Configuration Tool II Release Notes

VERSION 4.2.1.10 (24/03/17)

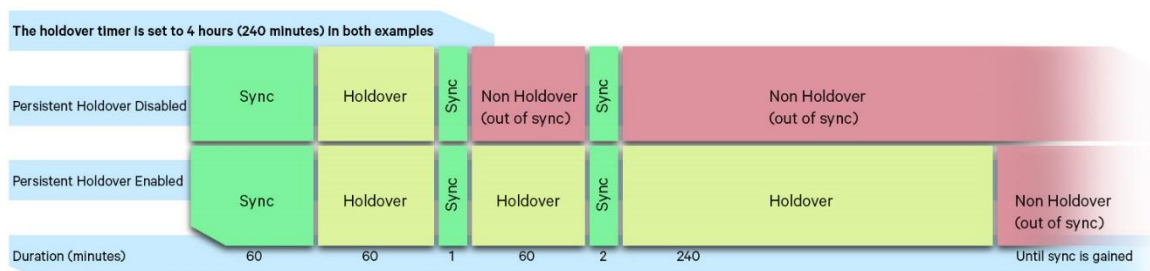
Feature: Added support for enabling the persistent holdover availability option on clocks that support it. Firmware version 3.20r1 or later is required to enable this option.

Normally, the clock can only enter holdover if it has been in sync for at least 5 minutes. If persistent holdover is enabled, and the clock has initially been in sync for at least 5 minutes, then the clock can still enter holdover if it experiences a sync switching condition. For example, sync is lost, regained for less than 5 minutes, then lost again. Such a condition may exist when GNSS jamming is present, or in the case of a poor antenna installation.

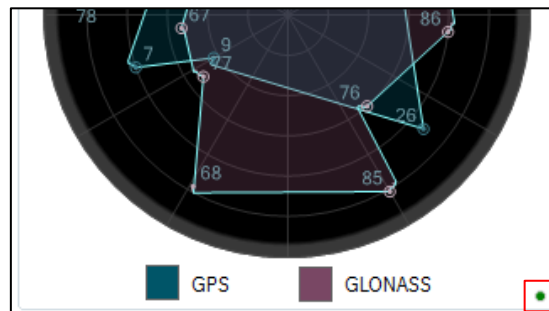
- Improvement:** The clock source priority settings are now a list that can be reordered by dragging and dropping. An 'Override Quality' checkbox has been added which, when selected, will force the chosen priorities to take effect instead of the default behaviour. The default behaviour is to use the clock source with the best accuracy, and only use the configured priorities when multiple clock sources have the same accuracy.

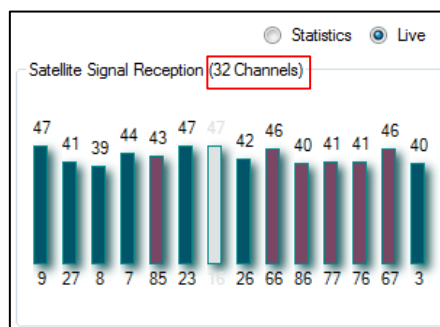
- Improvement:** An incoming data indicator has been added to the GPS/GNSS Live Satellite Visibility display. This indicator flashes green when live satellite data is being received from the clock, flashes yellow when the GPS/GNSS receiver has been reset, and flashes red if there is a problem with the data.

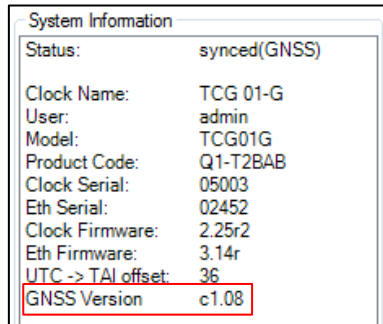
- **Feature:** Added support for configuring the PRPTP Translator.
- **Improvement:** The GPS/GNSS receiver firmware version is now shown under System Information on the Clock tab.
